RE: Quarry Walk, Yorklyn Road Hockessin
Temporary Holding Tank Application
Lots 1 through 16 and Lots 20 through 28 (25 Lots)
Tax Parcel #'s 08-008.10-117 to -120, 08-008.10-083 to -103
REVISED

TEMPORARY HOLDING TANK LOCATION PLAN

IM1530 SERIAL CONNECTION FIELD

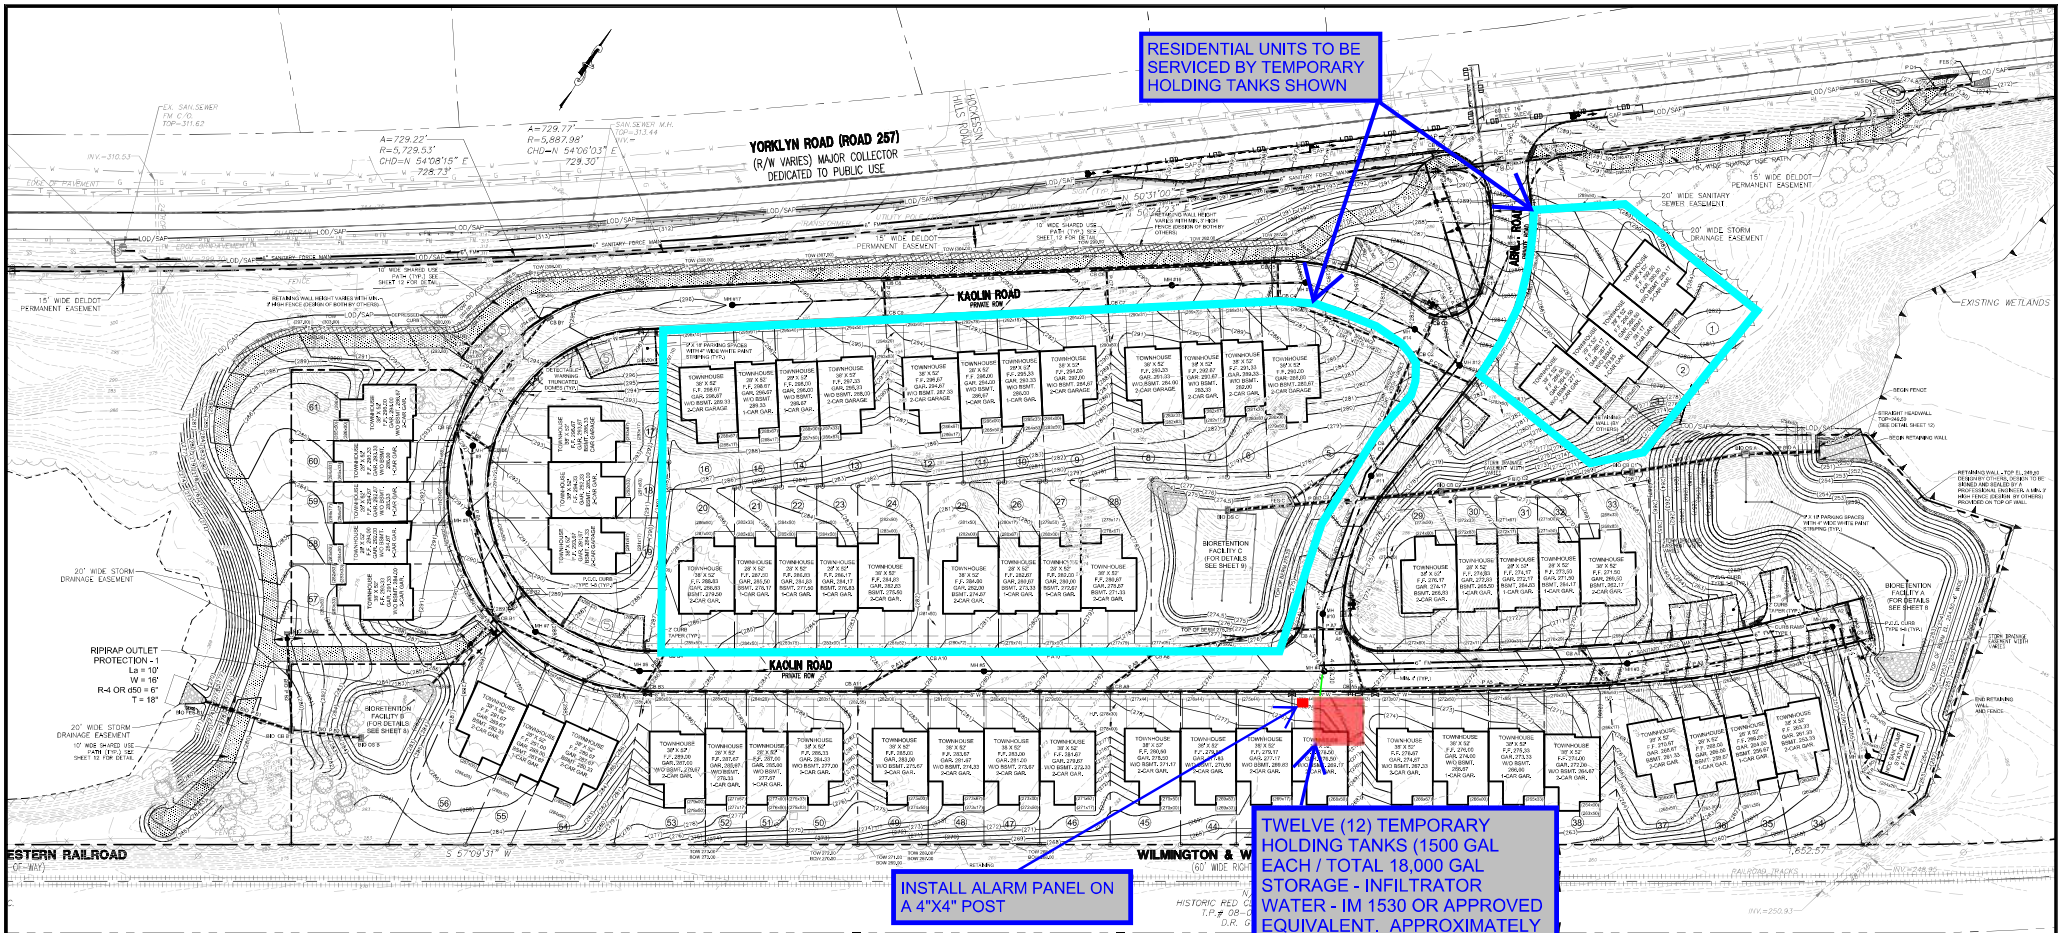
2024-0208 REVISED TO ADD TWO (2) ADDITIONAL TANKS FOR A TOTAL OF 12

TWELVE (12) TEMPORARY HOLDING TANKS (1500 GAL EACH / TOTAL 18,000 GAL STORAGE - INFILTRATOR WATER - IM 1530 OR APPROVED EQUIVALENT. APPROXIMATELY 39' X 34' FOOTPRINT

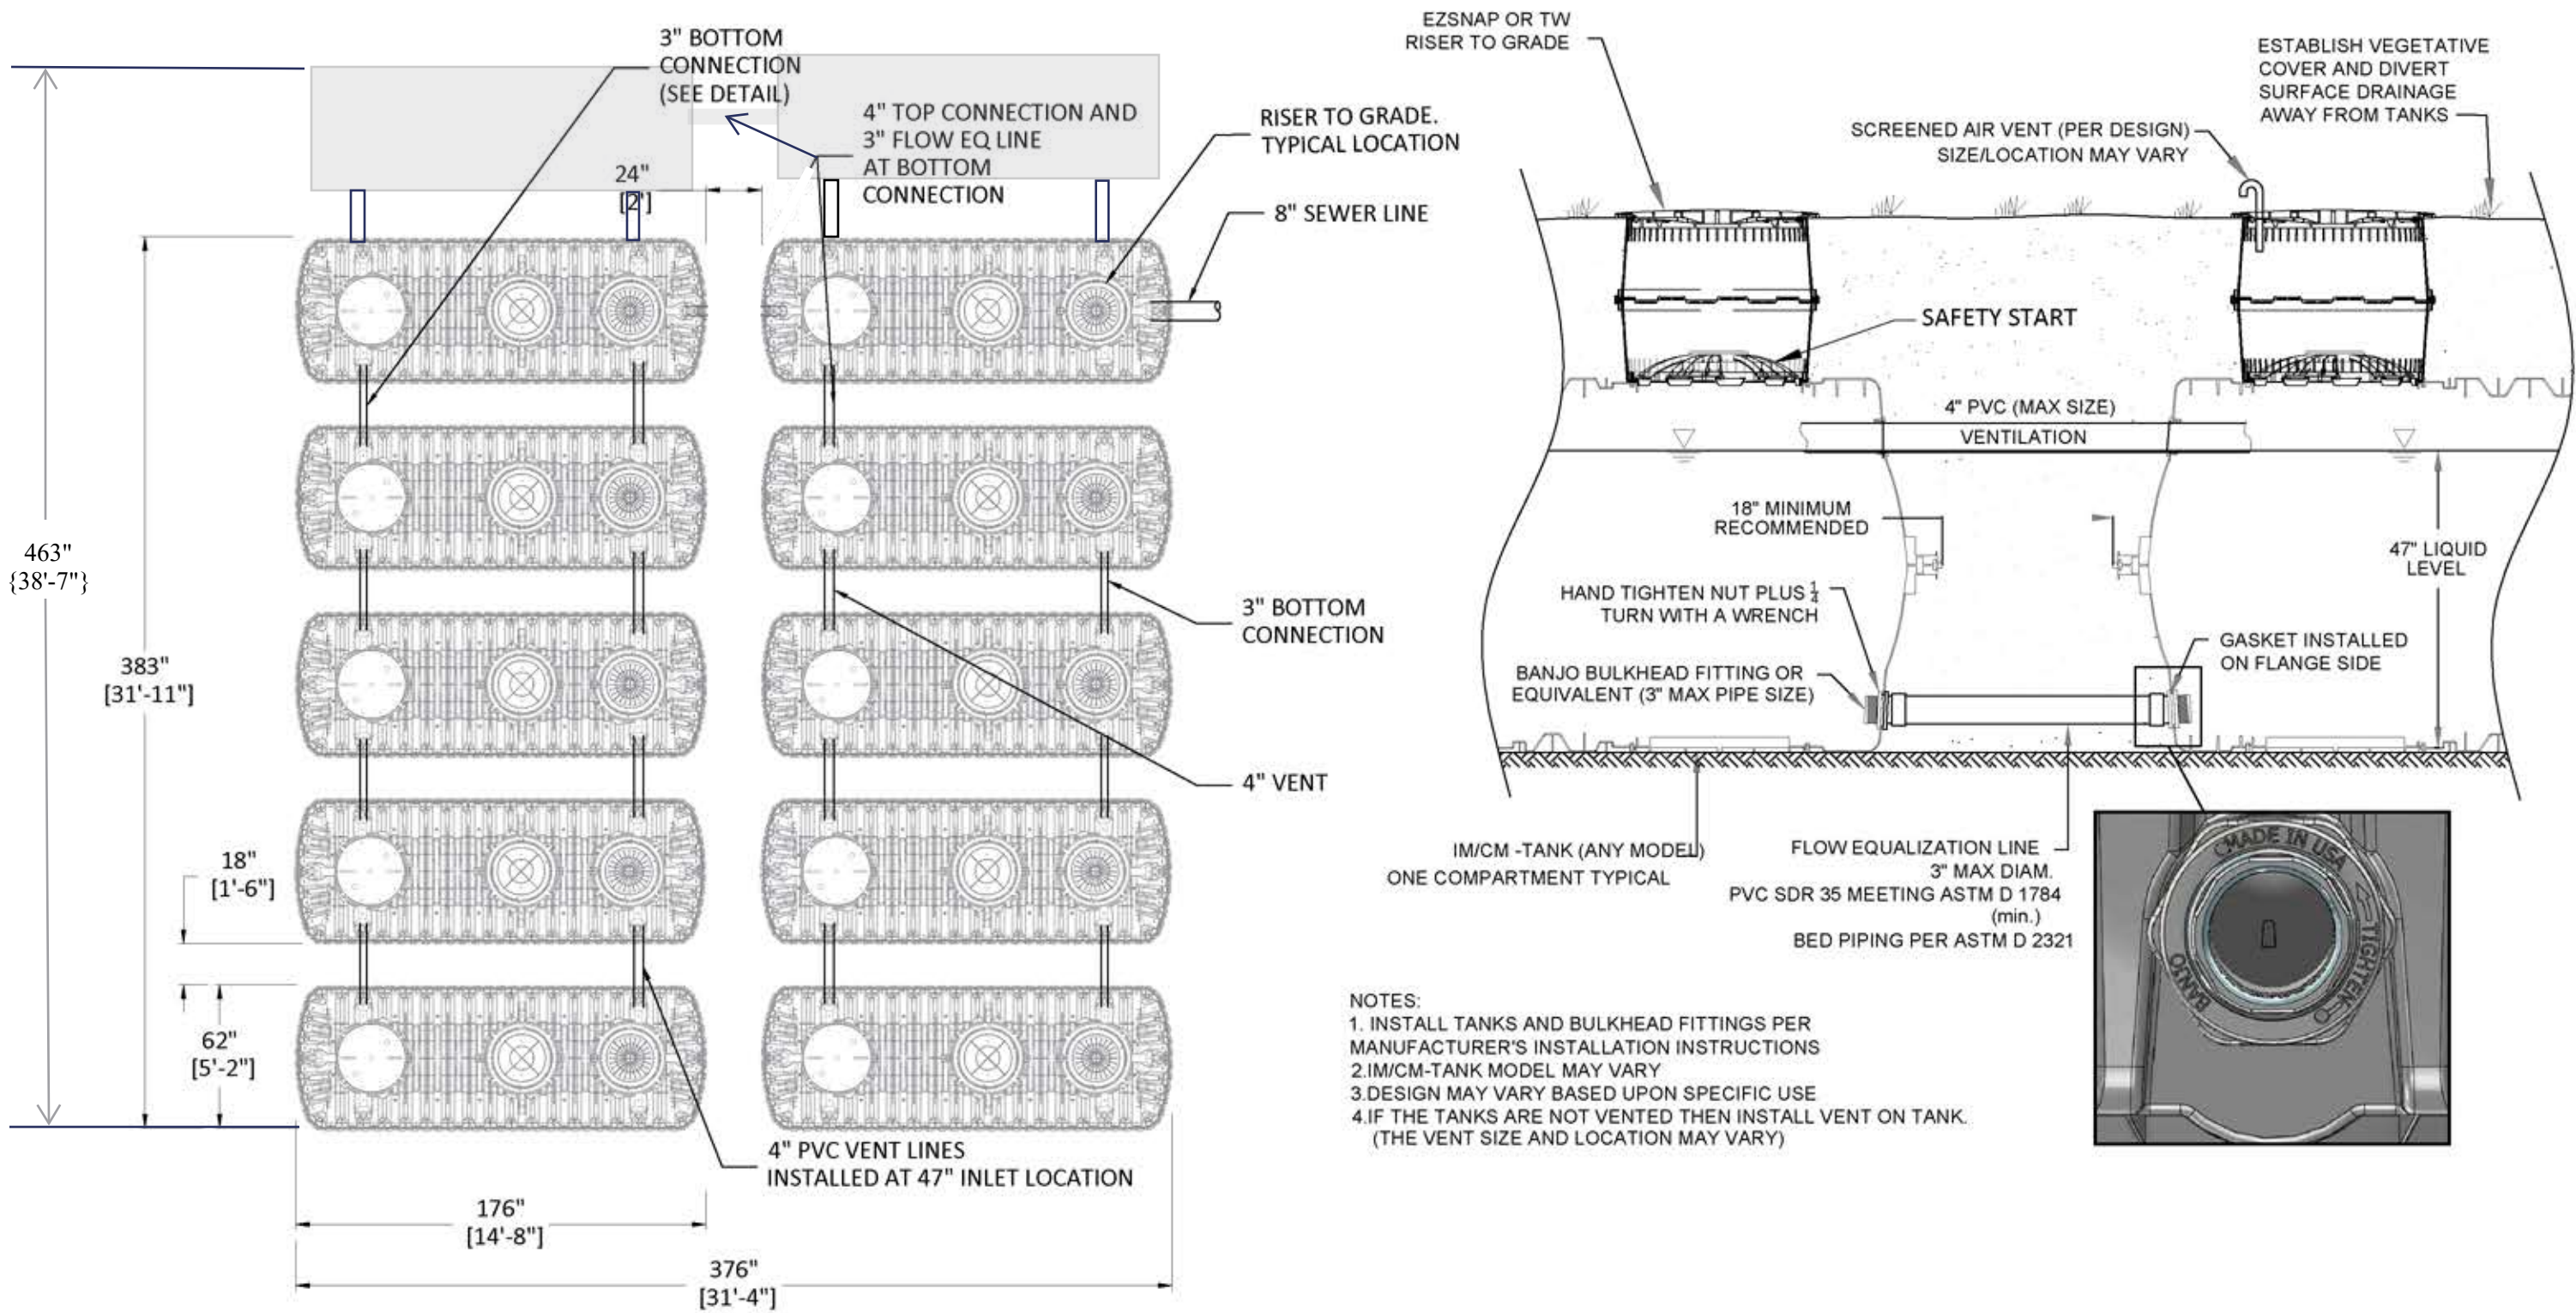
REVISED 2024-0208 ADDED TWO (2) ADDITIONAL TANKS FOR A TOTAL OF 12
